**ISSUE:** Permit to Demolish/Capsulate (partial) and Certificate of Appropriateness for alterations

**APPLICANT:** Elindale, LLC; Scott McElhaney

**LOCATION:** Old and Historic Alexandria District  
722 King Street

# 722/724 KING STREET - BAR APPLICATION FOR CERTIFICATE OF APPROPRIATENESS FOR ALTERATION TO EXISTING FACADE

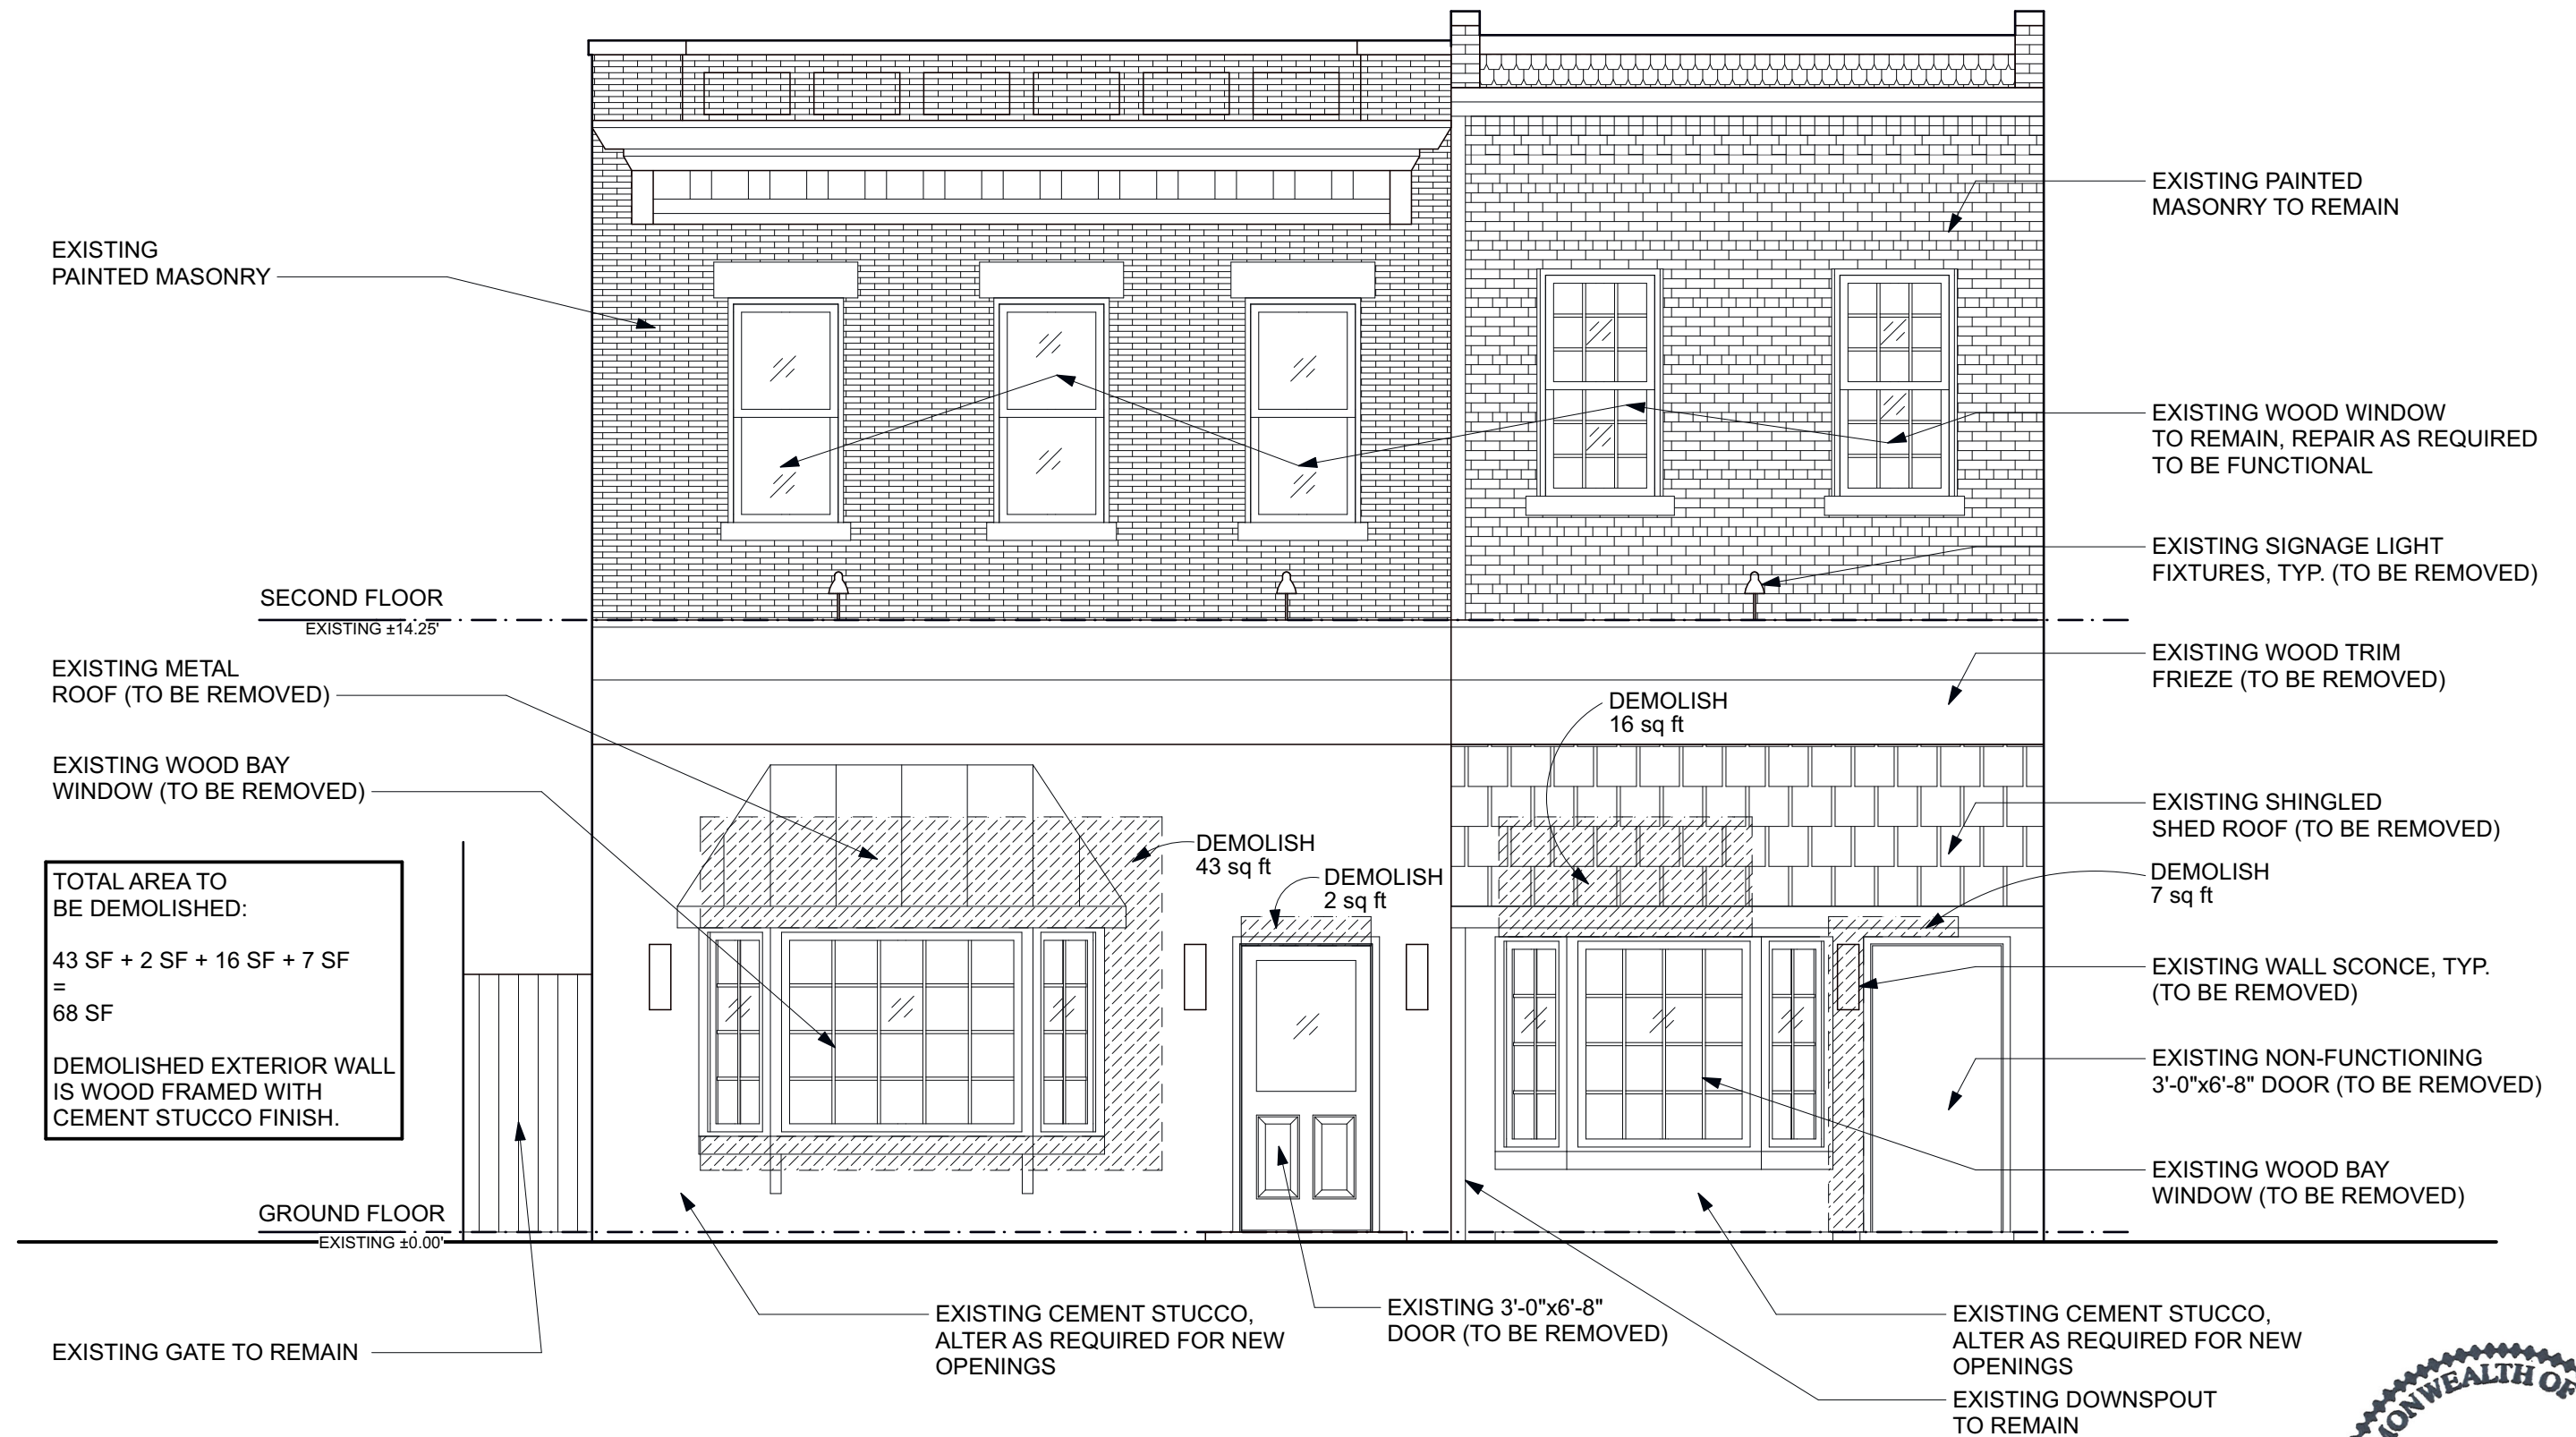
1. Install the linear sign lighting only in the bottom moulding of the frieze, shining up, so that it does not glare in the eyes of pedestrians.

Staff also supports replacing the current doors and windows with new wood-framed doors and windows with PVC trim. In the past, the BAR has typically approved solid cellular, paintable, millable PVC with traditional detailing on storefront framing due to the ease of maintenance and because it did not replace any historic materials on the first floor of retail buildings along King Street. The existing modern wood frieze will be replaced with PVC framed by moulding and an integral, linear LED light will extend across the moulding at the top to wash the future signs below. Staff recommends that the linear sign lighting be installed only in the bottom moulding of the frieze, shining up, so that it does not glare in the eyes of pedestrians below.
